July 2021: For the purposes of the environmental permit application Ref EPR/HP3509MM/A001 please refer to the Site Layout Plan (Appendix C, Application Support Document, Dated June 2021) for current site process arrangements relating to permitted activities.

| AD ANDIDRAIN | | CLIENT : UNITED UTILITIES | |
| DRAIN CLEARANCE - SEWER SERVICES | | Drawing Title : BURMLEY WWTW | |

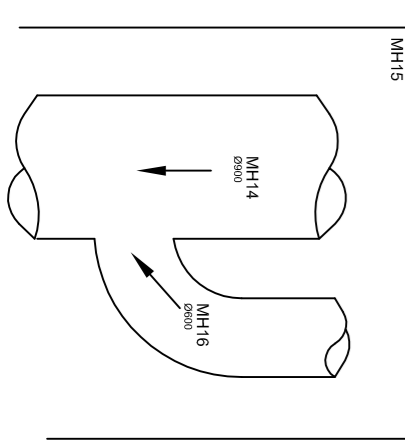
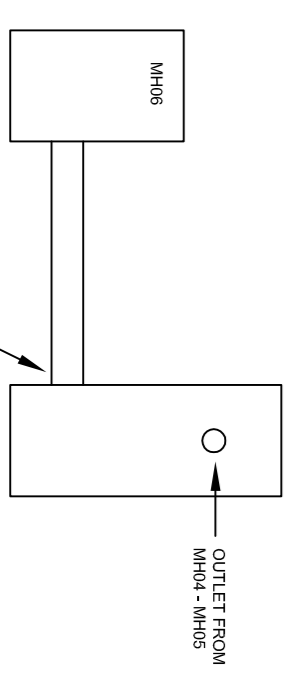
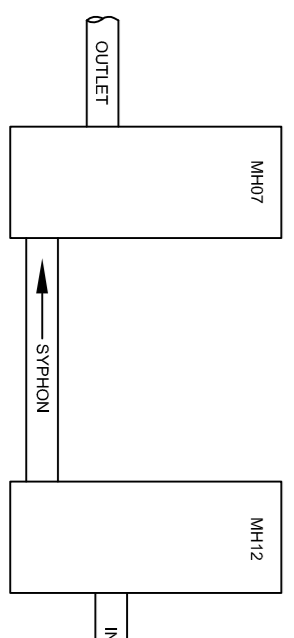
MANHoles INSTALLED IN GROUP ARE IN HIGHER THAN THAT OF THE GROUP PIPE RESULTING IN THE CREATING A SIFT TRAP

REASON WHY MANHoles SITS FULL OF WATER
